**CITY OF VANCOUVER  
PLANNING & DEVELOPMENT SERVICES**

**DEVELOPMENT PERMIT STAFF COMMITTEE  
MEETING  
January 13, 2021**

**2106 W 8<sup>th</sup> Avenue (COMPLETE APPLICATION)  
DP-2018-00490 – RM-4**

Figure 1 – Explanatory plan indicating the requirements of Condition A.2.1 a, b, and c.

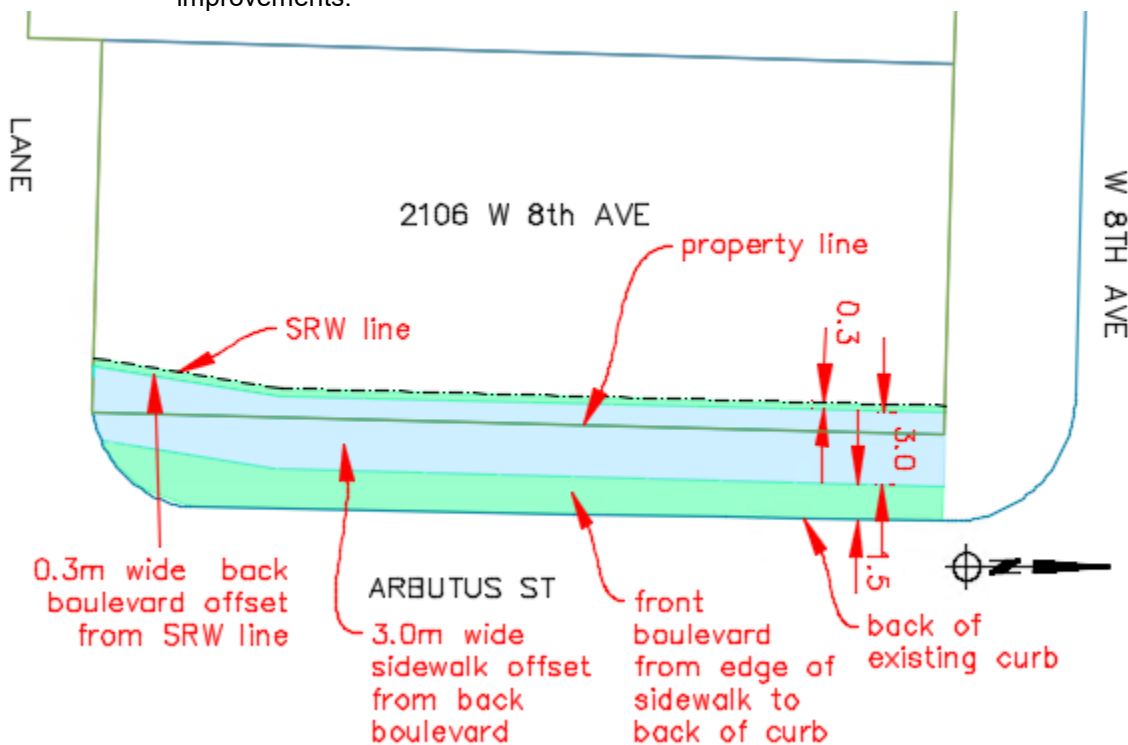
### A.2.1 Provision of the following improvements to the satisfaction of the General Manager of Engineering Services:

- i. Street improvements along Arbutus Street adjacent to the site and appropriate transitions including the following. These dimensions are provided as offset distances from the ultimate edge of the SRW area:

- a. 0.3m wide sod grass back boulevard;
  - b. 3.0m wide broom finish saw-cut concrete sidewalk;
  - c. Front boulevard in the remaining space between the edge of the sidewalk and the back of the curb;
